ADDENDUM #1

PROJECT: Bridge Classroom Portable at Beckman ES
Lodi Unified School District

DATE : June 2, 2026

ELECTRICAL PLAN

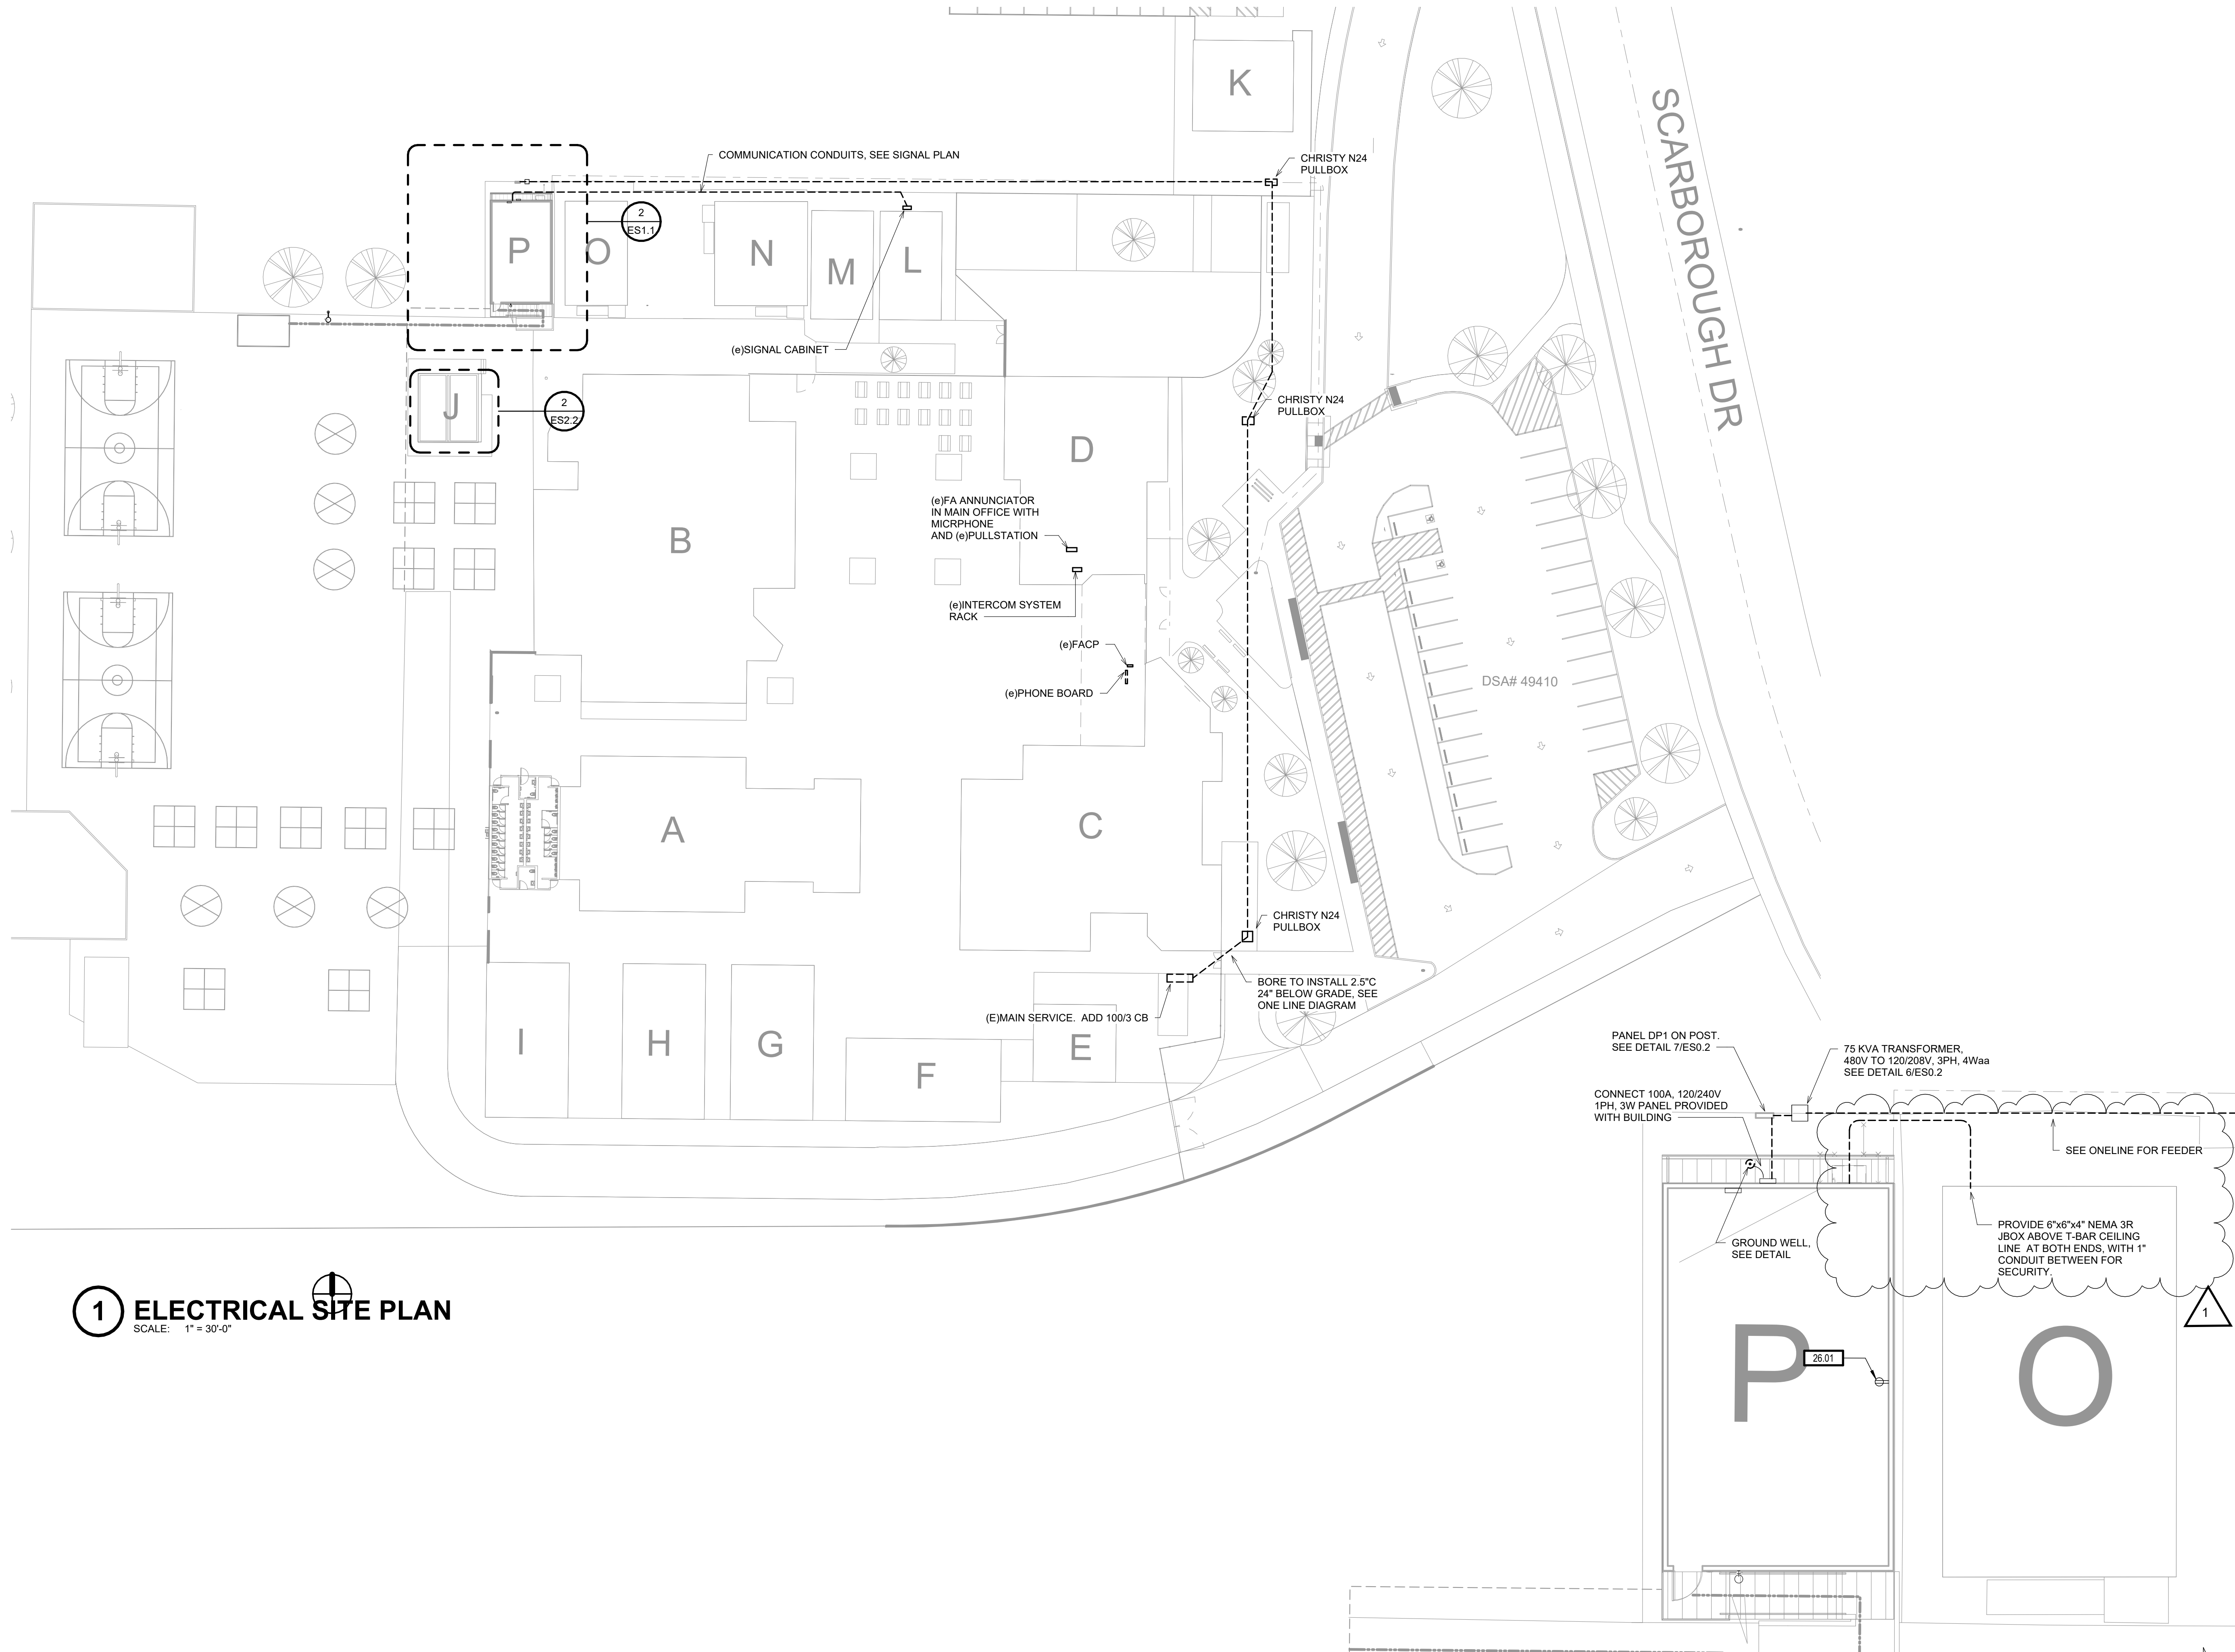
ITEM 4 Intrusion Alarm

The contractor is to provide pathways / wiring for Intrusion Alarm systems, including 6"x6"x4" Nema 3R J-boxes above T-bar ceiling at portable buildings with 1" conduit pathway between new and existing portable as described on revised sheet 1-ES1.1. The District is to supply and install the intrusion alarm devices.

SIGNAL PLANS

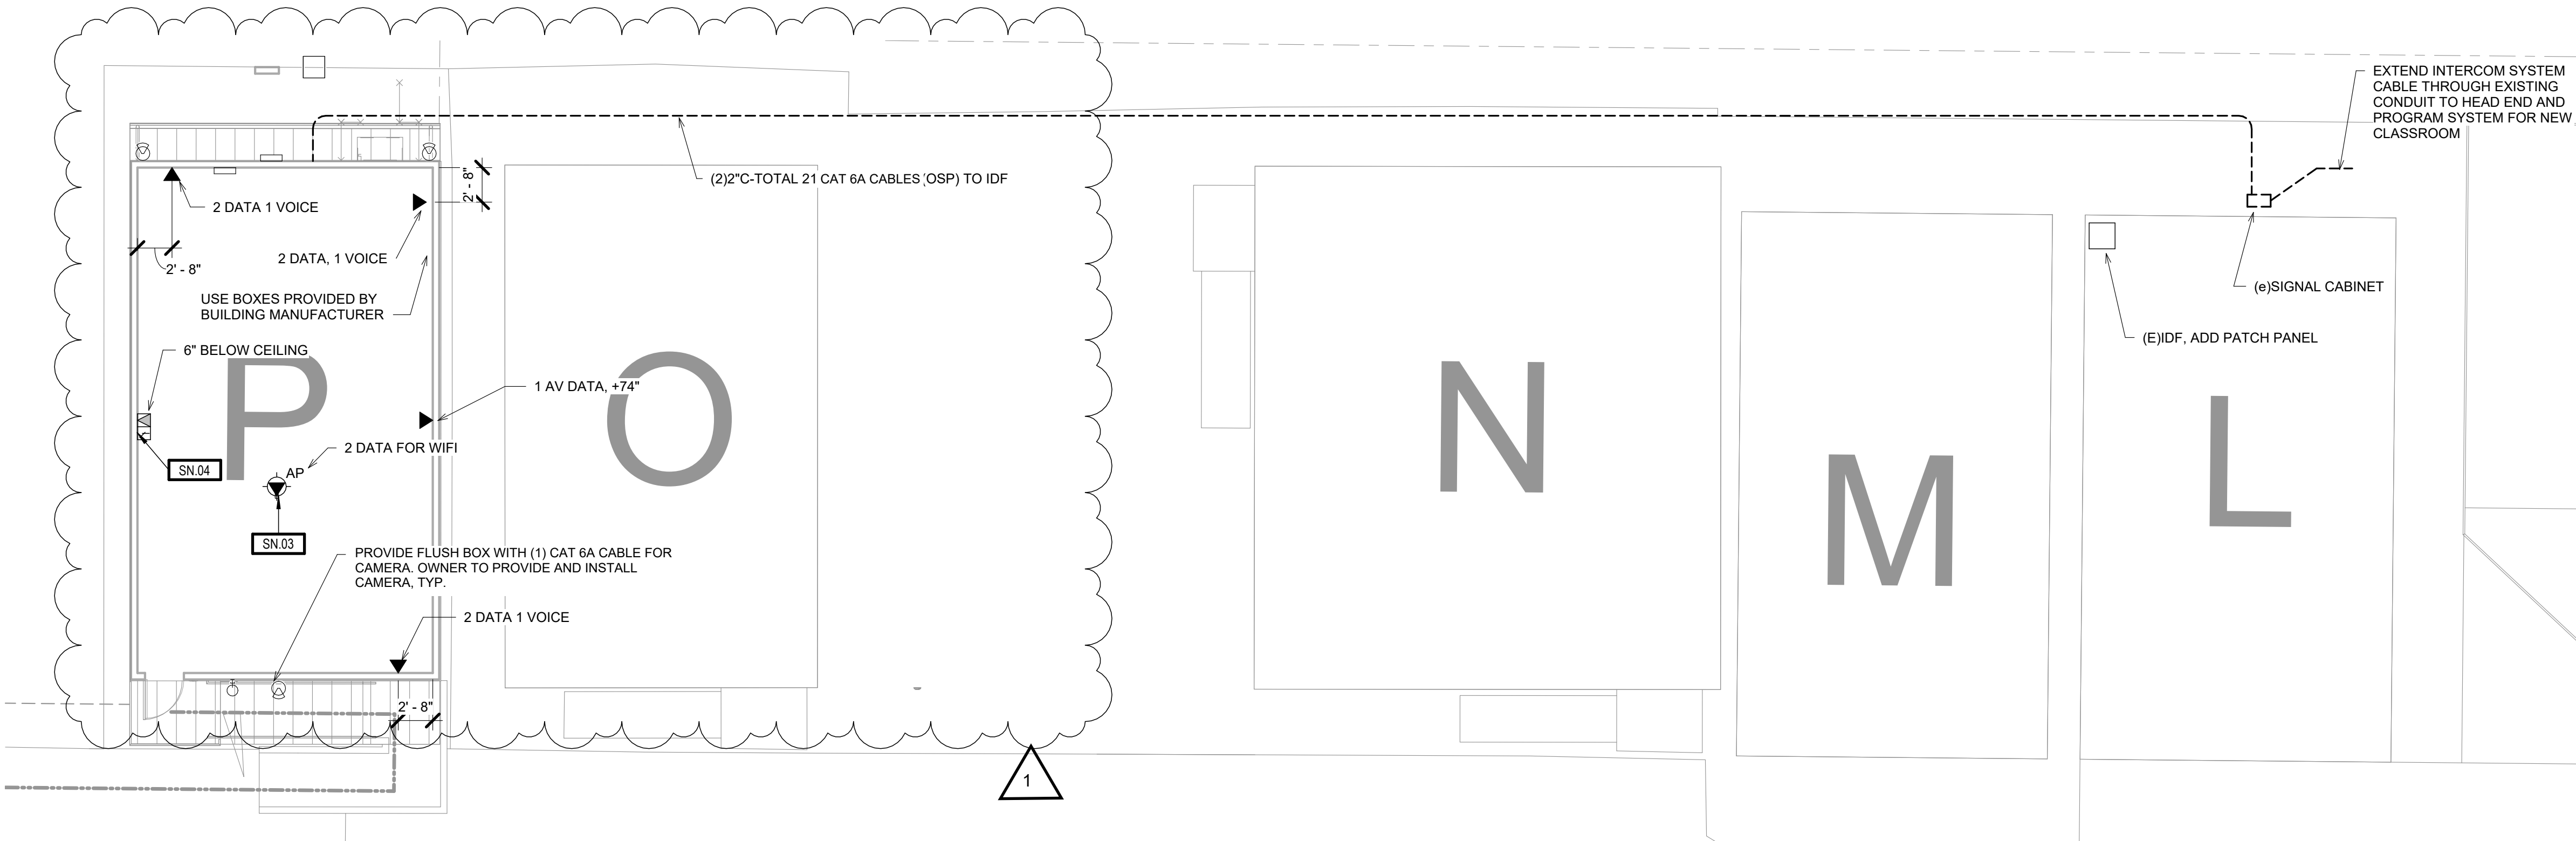
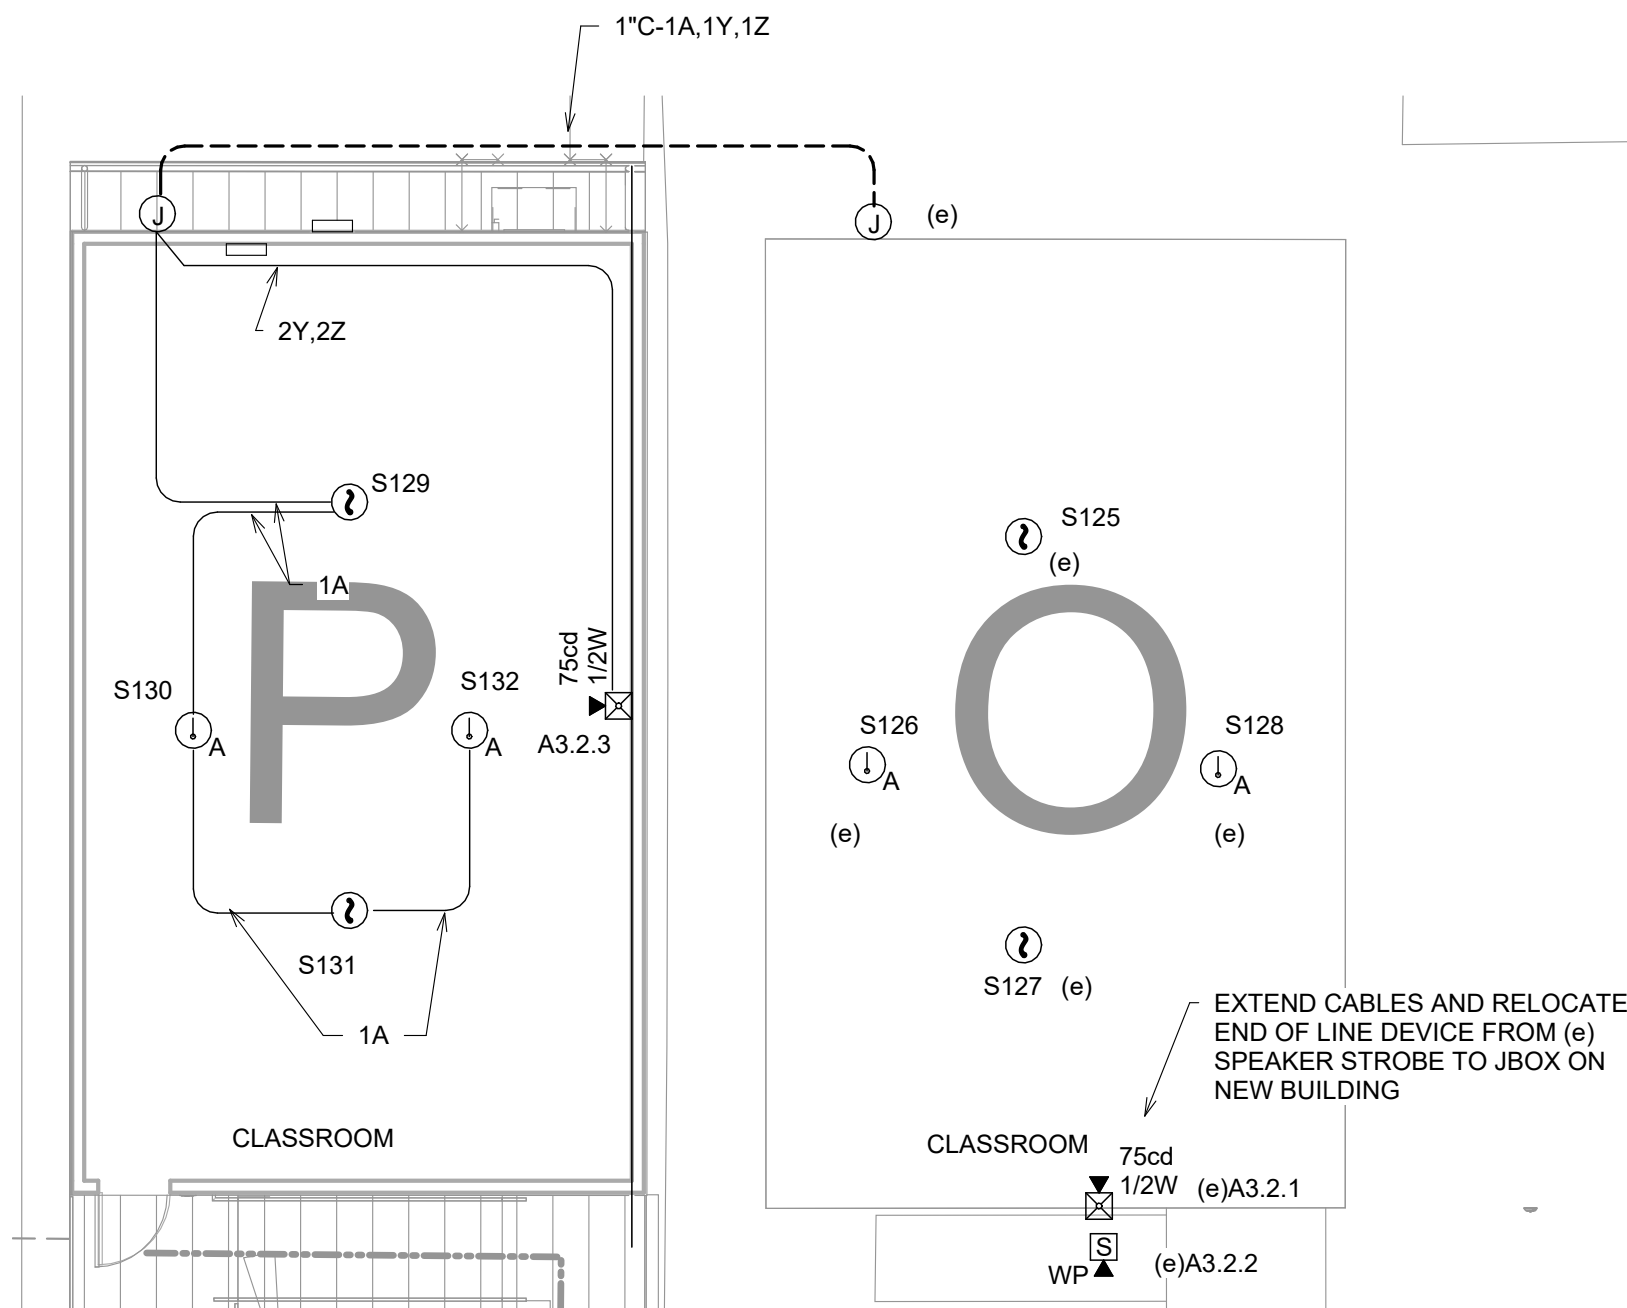
ITEM 1 Revised data and low voltage layout.

Contractor to provide CAT 6A wiring for low voltage and data equipment per the revised layout on sheet 1-ES2.1.

SHEET NOTES	
SN.03	PROVIDE (1) CAT6A FOR WIRELESS ACCESS POINT
SN.04	PROVIDE SURFACE MOUNT CLOCK/SPEAKER TO MATCH THE EXISTING SYSTEM, MOUNT AT 84" TO TOP. PREWIRE WITH CAT 6A CABLES THROUGH EXISTING CONDUITS TO IDF FOR SPEAKER. CLOCK TO BE BATTERY POWERED AND INSTALLED BY THE DISTRICT. PROVIDE ACCESSORIES AND PROGRAMMING AS REQUIRED.
